27 October 2023  
Our File Ref: B23312AL001  
Contact: Bridget Wouts

RE: **LINK ROAD MIXED USE PRECINCT – BANKSTOWN AIRPORT**  
**AIRPORT SAFEGUARDING ASSESSMENT – PRELIMINARY ASSESSMENT**

L+R Airport Consulting were engaged by Bankstown Airport Limited (BAL) to undertake an airport safeguarding assessment at key design documentation stages through the Major Development Plan process as it relates to Bankstown Airport against the National Airports Safeguarding Framework (NASF) Guidelines. This assessment is based on the Preliminary Documentation stage.

**Maximum Intensity of Light Sources Measured at 3° Above the Horizontal**

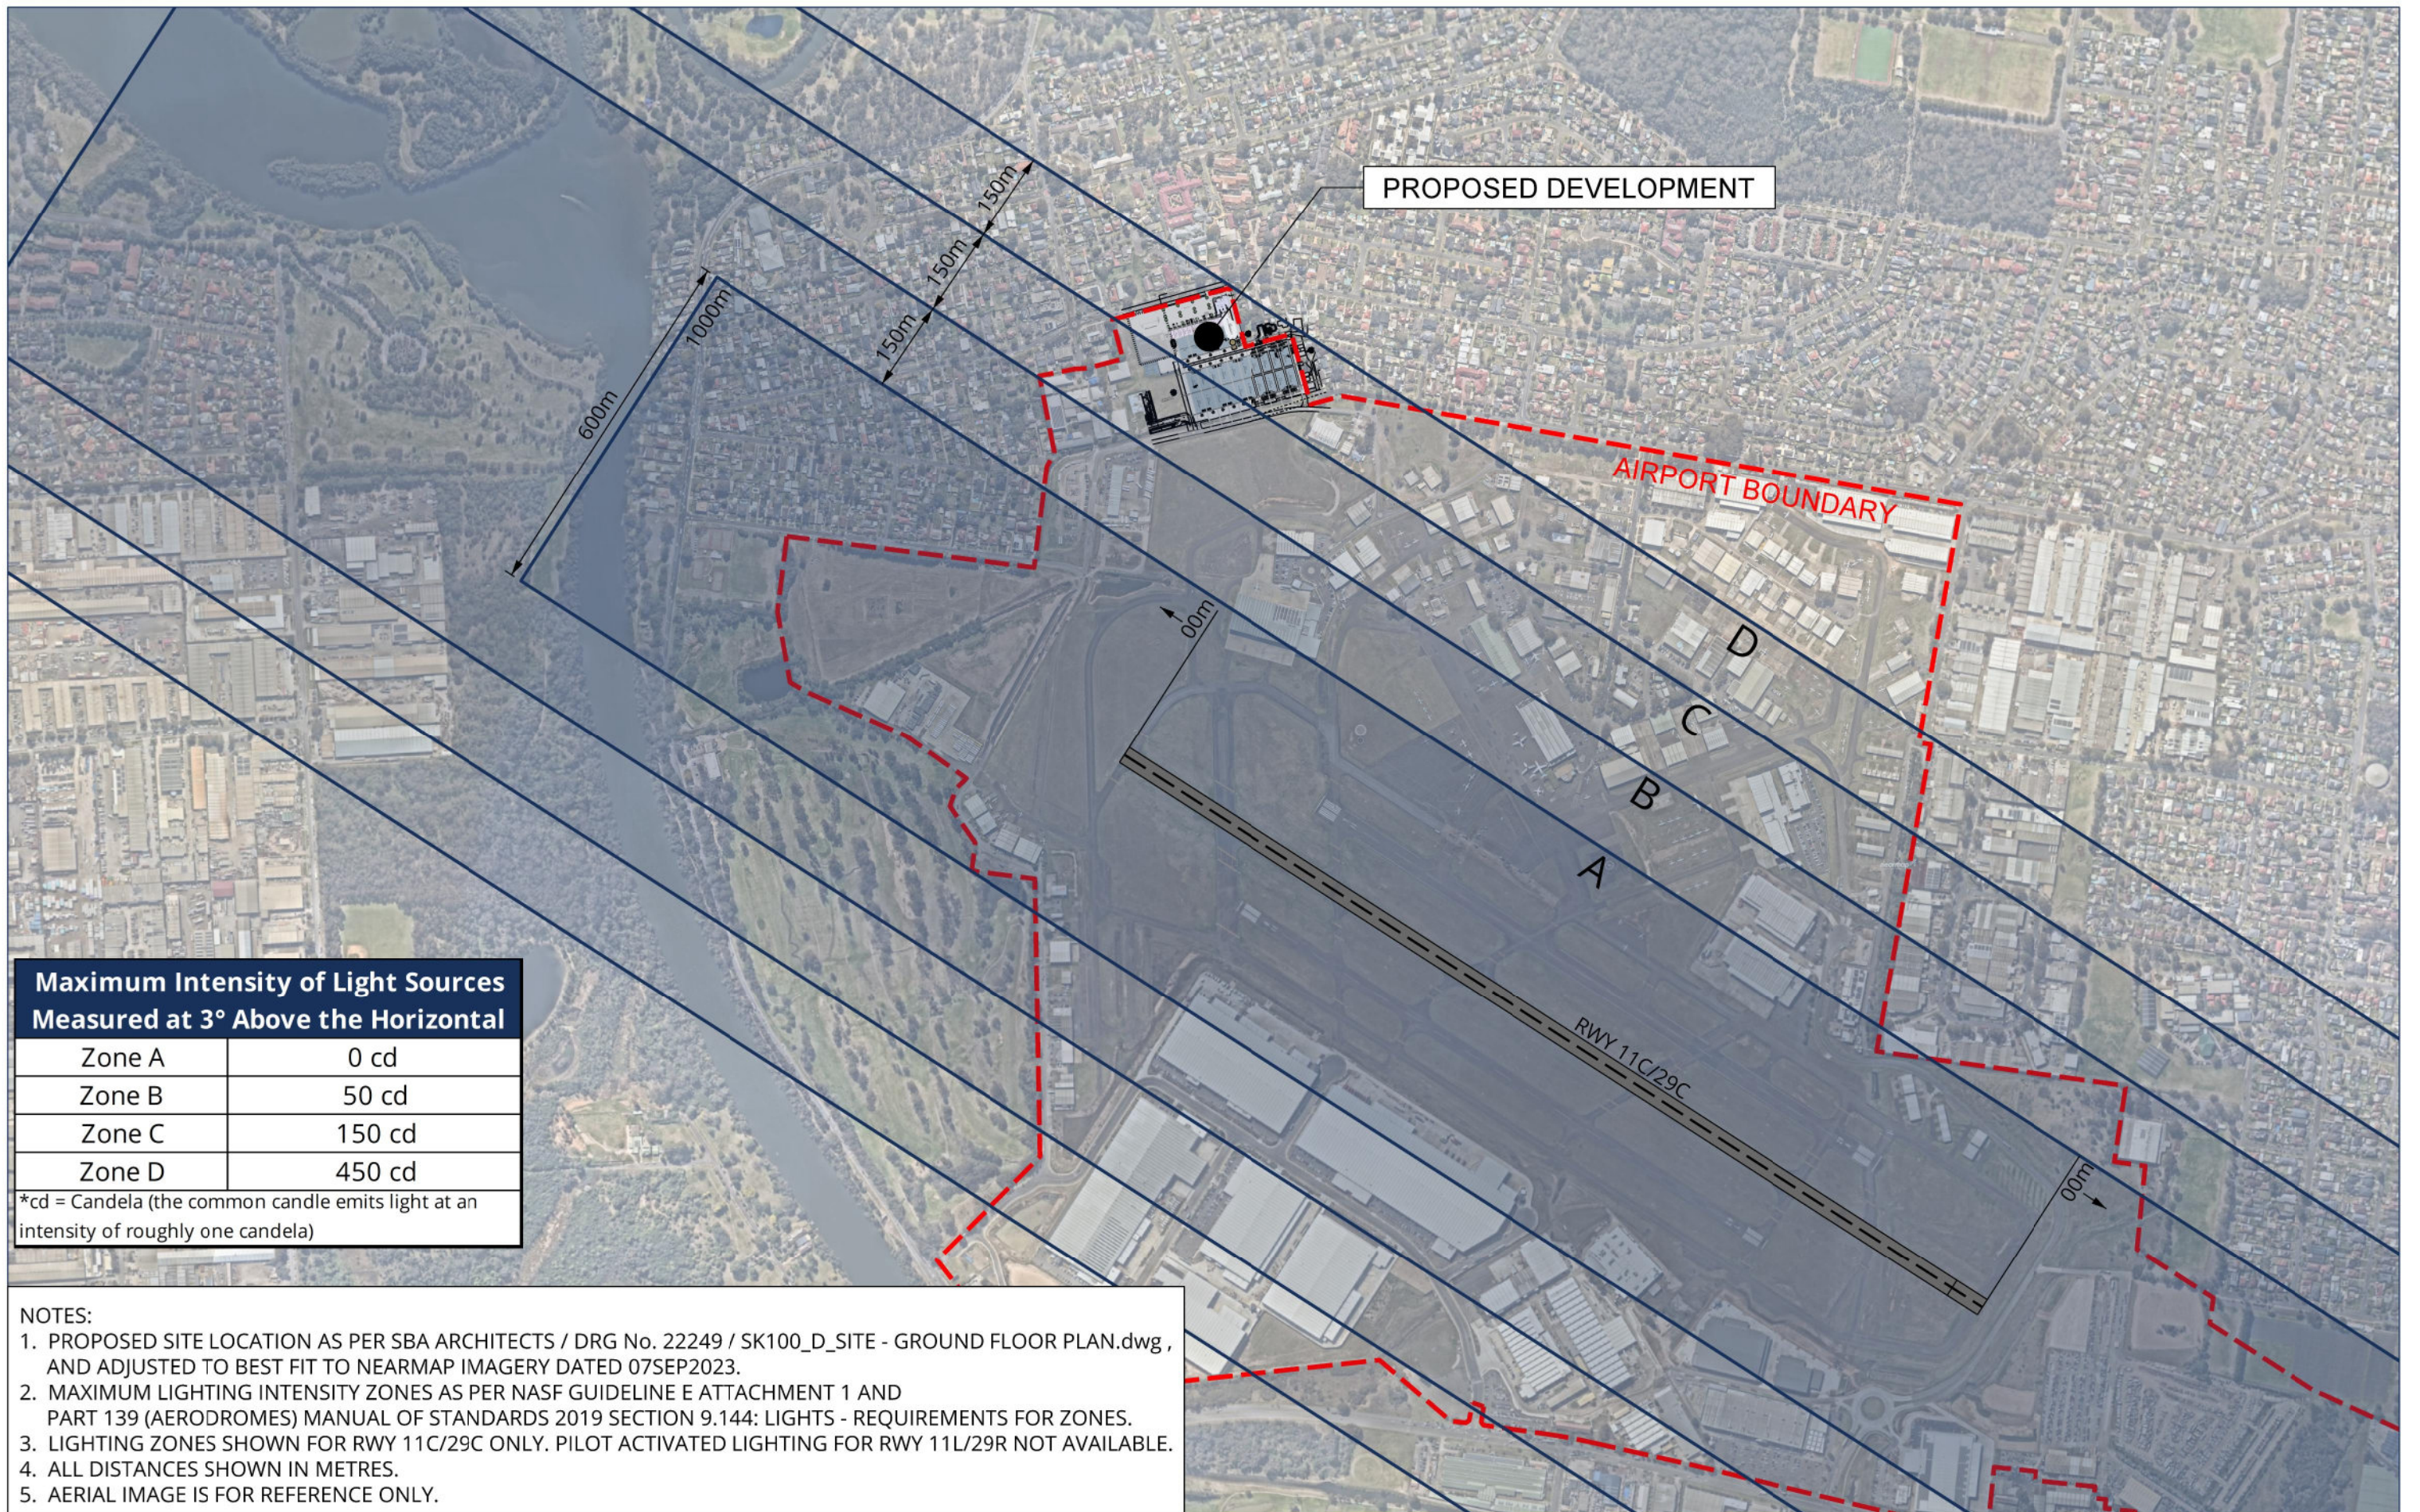
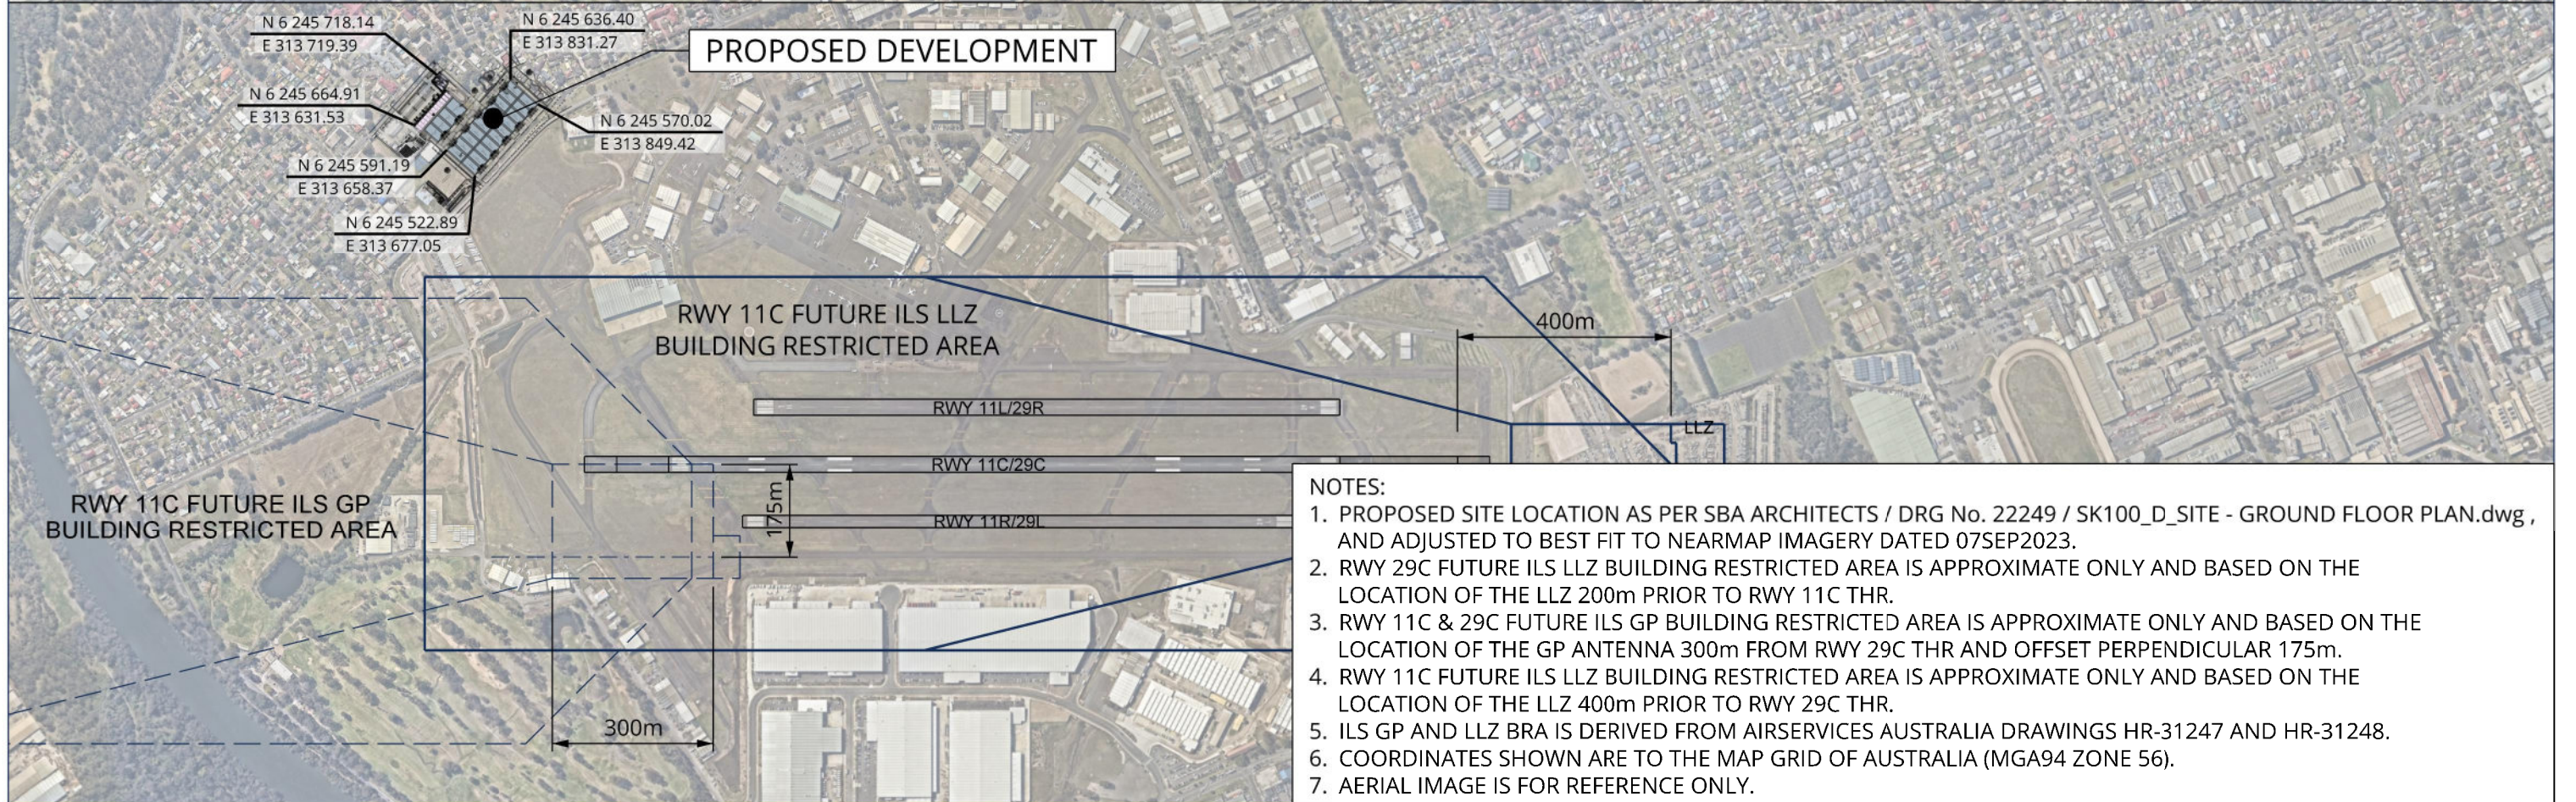
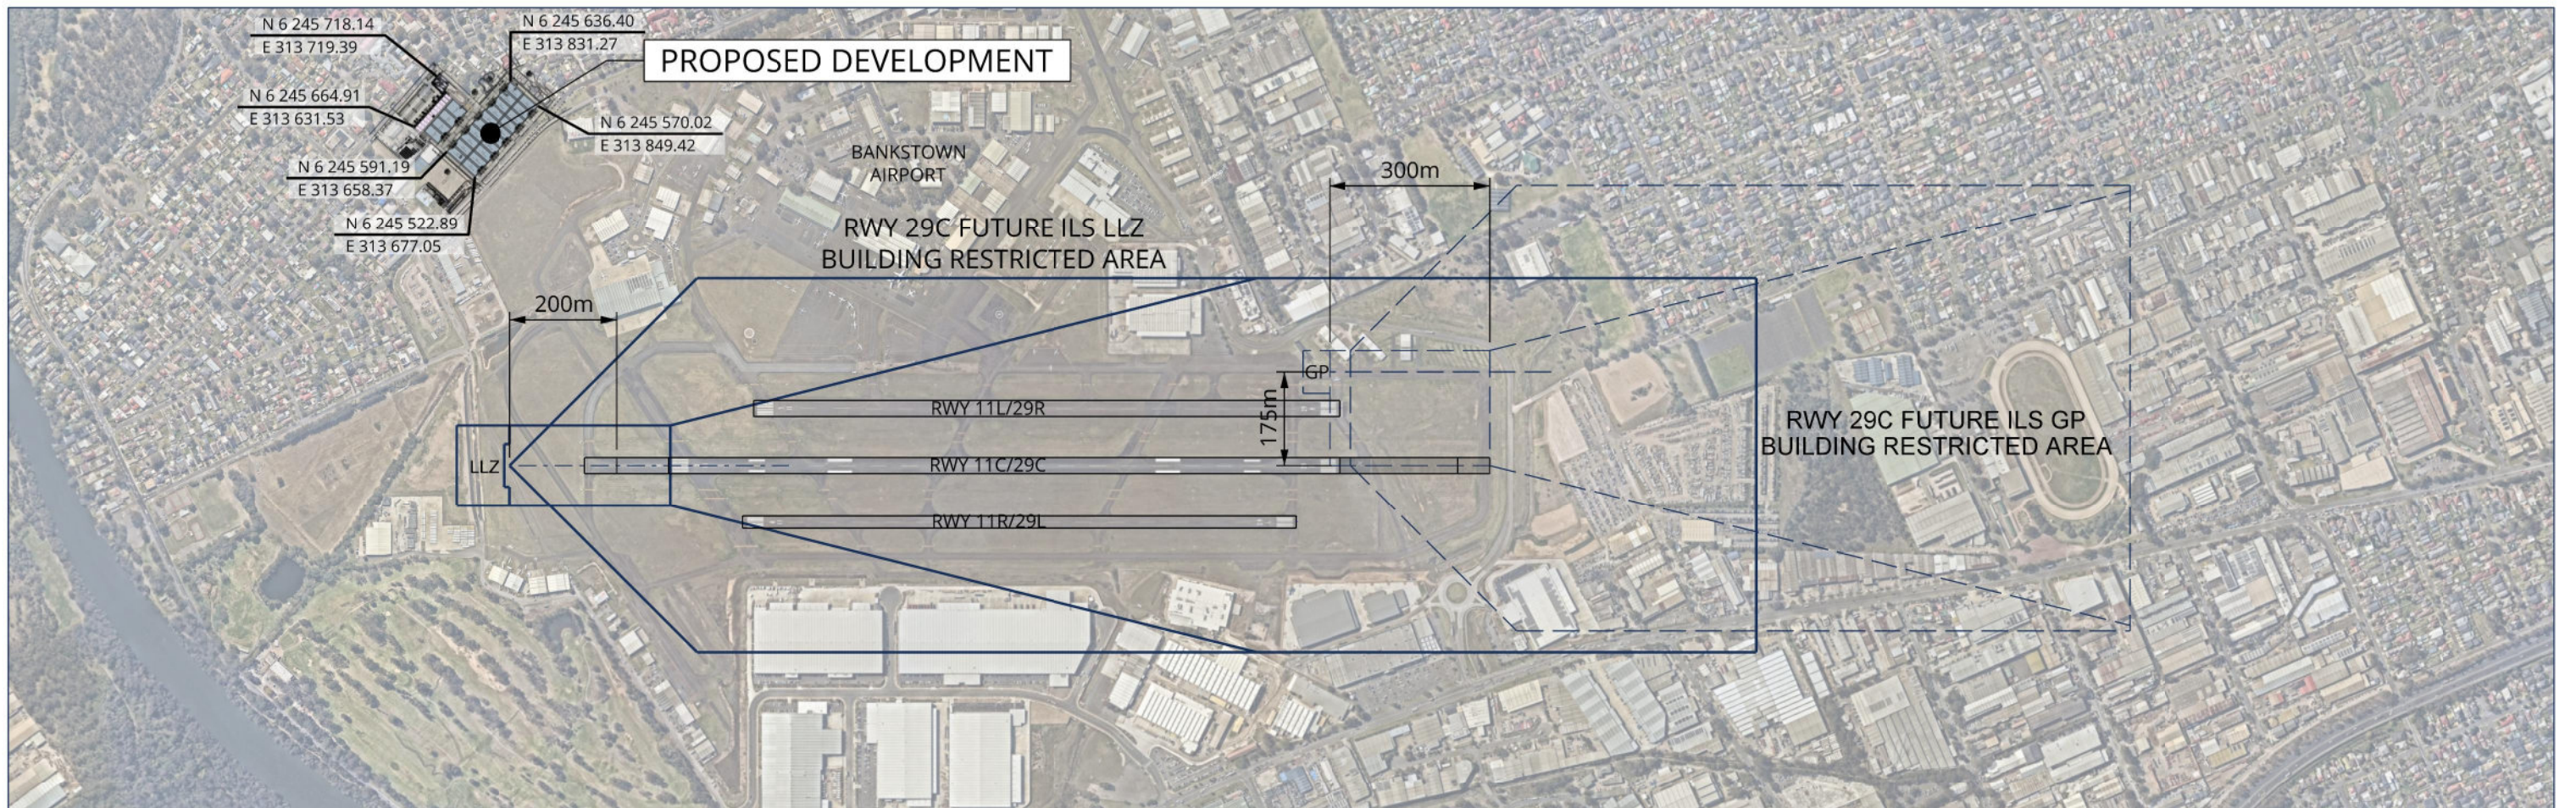
NASF Guideline E provides guidance on the risk of distractions to pilots of aircraft from lighting and light fixtures near airports. The *CASA Part 139 (Aerodromes) Manual of Standards 2019* Section 9.144: *Lights – requirements for zones* sets out the restrictions and degree of interference ground lights can cause as a pilot approaches, and provides advice to lighting designers and suppliers. The proposed development site is within the light control zones as illustrated on Figure B23312/08.

Lighting zones shown are for Runway 11C/29C only. Permanent lighting for Runway 11L/29R is no longer available but rather only portable lighting. As such lighting zones for Runway 11L/29R have not been included.

The proposed development is partially within light control Zone C and the remainder is within Zone D. Any lighting associated with the proposed development should therefore meet the restrictions associated with Zone C. Zone C allows for 150 cd intensity of light sources measured 3 degrees above the horizontal.

The design of lighting should take into consideration Guideline E to ensure there is no conflict from light fittings, coloured lights or glare caused by reflective surfaces and/or mitigation measures to be put in place. The lighting designer will need to ensure that the lights meet the requirements prescribed in the *CASA Part 139 (Aerodromes) Manual of Standards 2019*.
